Re: Prediction of Noise Emissions from the Proposed Taurus Data Center in Colorado Springs

At the request of the City of Colorado Springs (City), Hankard Environmental, Inc. (HEI) developed an independent model of noise emissions from the proposed Taurus Data Center (Facility) to validate the noise report produced by D. L. Adams Associates (DLAA). This letter describes the noise modeling method, input data, and a comparison of HEI and DLAA predicted noise levels at the residences located south of the Facility.

Figure 1. Site Layout and Noise Contours

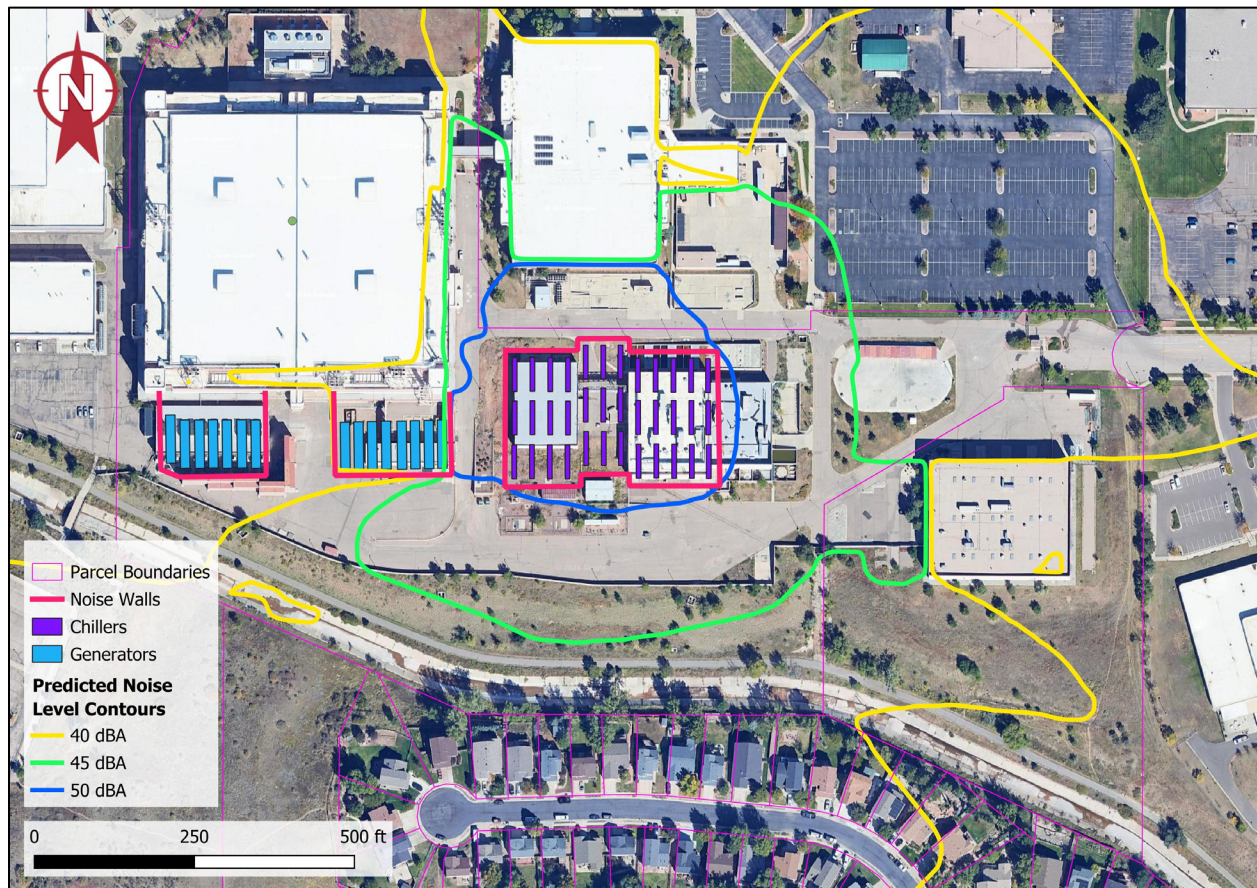
The HEI predicted noise levels agree well with those the results shown in the DLAA report (revised 05/12/2026), with a predicted level of 43 dBA at the nearest residential property line, compared to the 42 dBA predicted by DLAA. This is very good agreement.

HEI predicts noise levels ranging from 39 to 43 at points 25 feet inside the property line of the nearest residences along Chutney Street. Figure 1 shows the site layout, including generators, chillers, and noise walls. Predicted noise level contours for normal operation are also shown. The HEI and DLAA predicted noise levels for the generator scenario agreed as well.
